2012 ATV and ROV Updates

2012 ATV and Prowler Update

HDX Transmission Improvements

CAD of High Range Gear

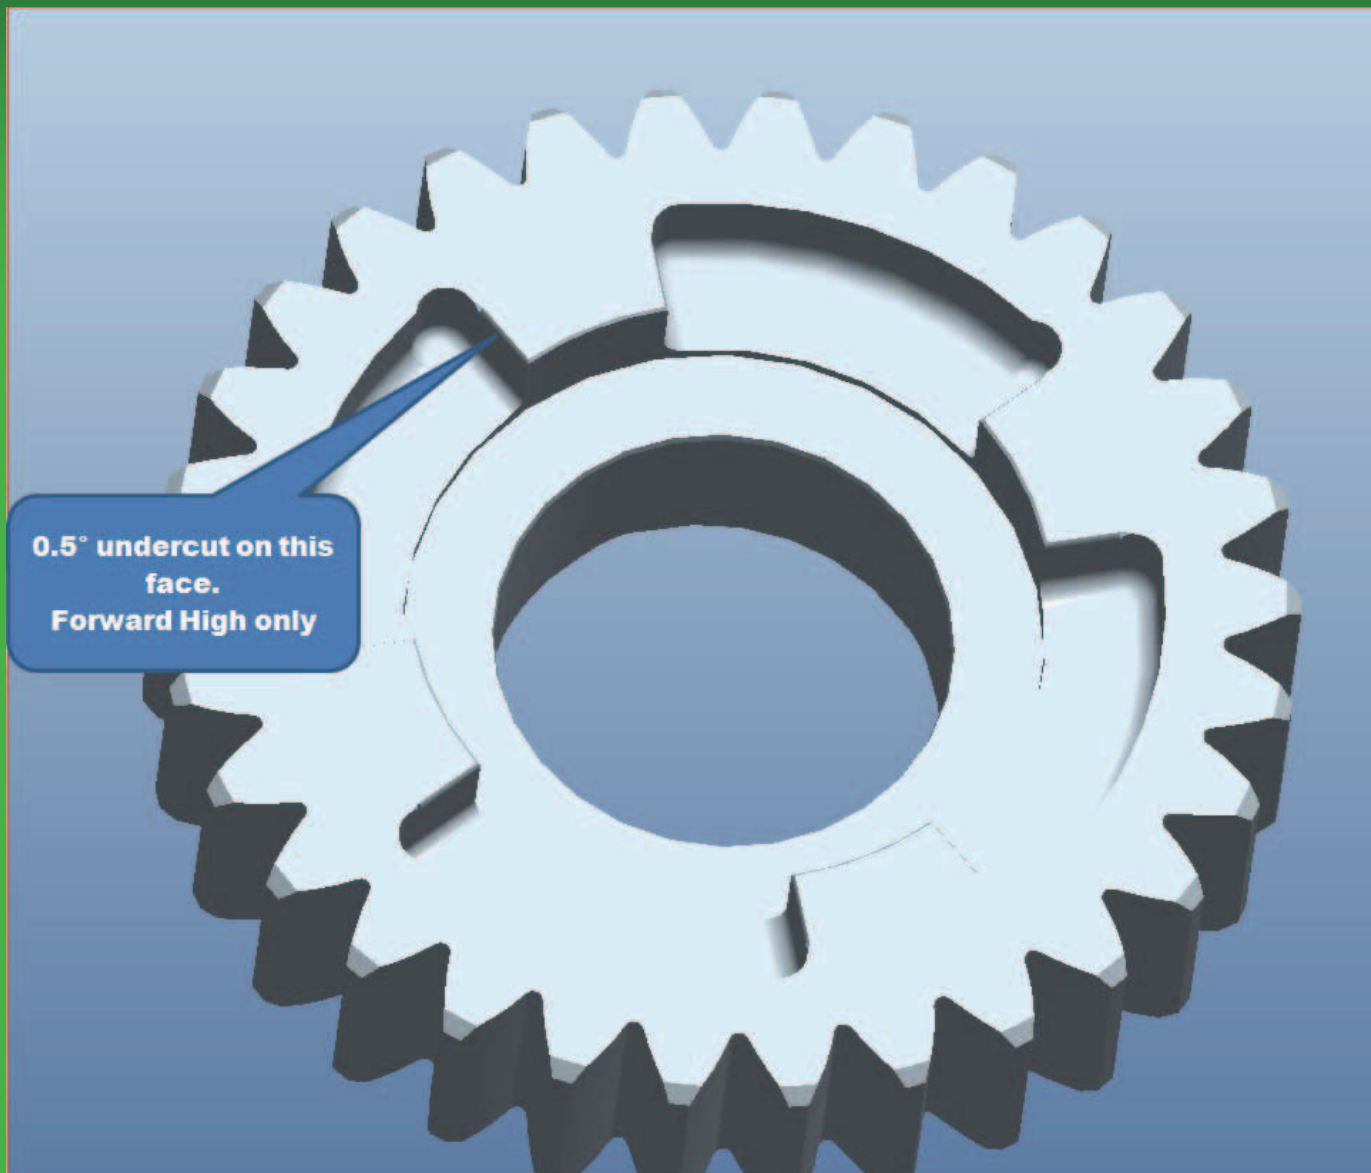
Driven High Range Gear

Engagement surface on the driven high range gear has 0.5° undercut to keep the gear and slider engaged

CAD of High Range /Reverse Gear Selector

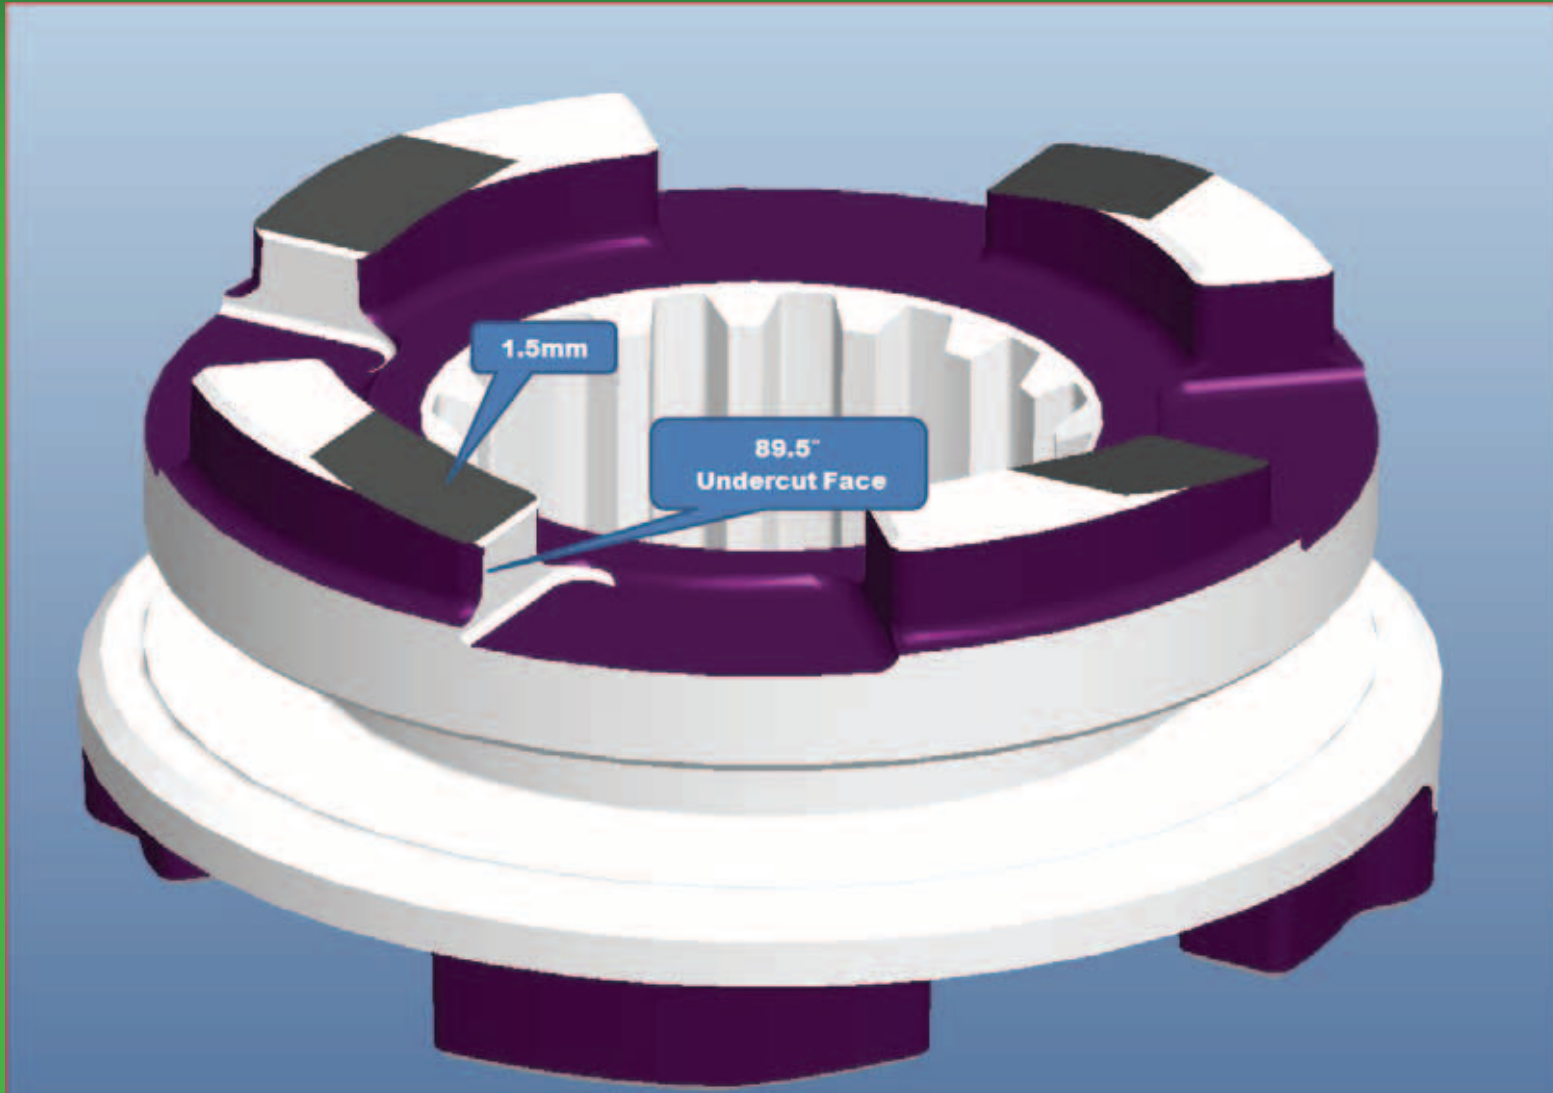
Sliding High Range / Reverse Gear Selector

The gear selector has an undercut of 89.5° to accommodate the modified area on the high range gear.
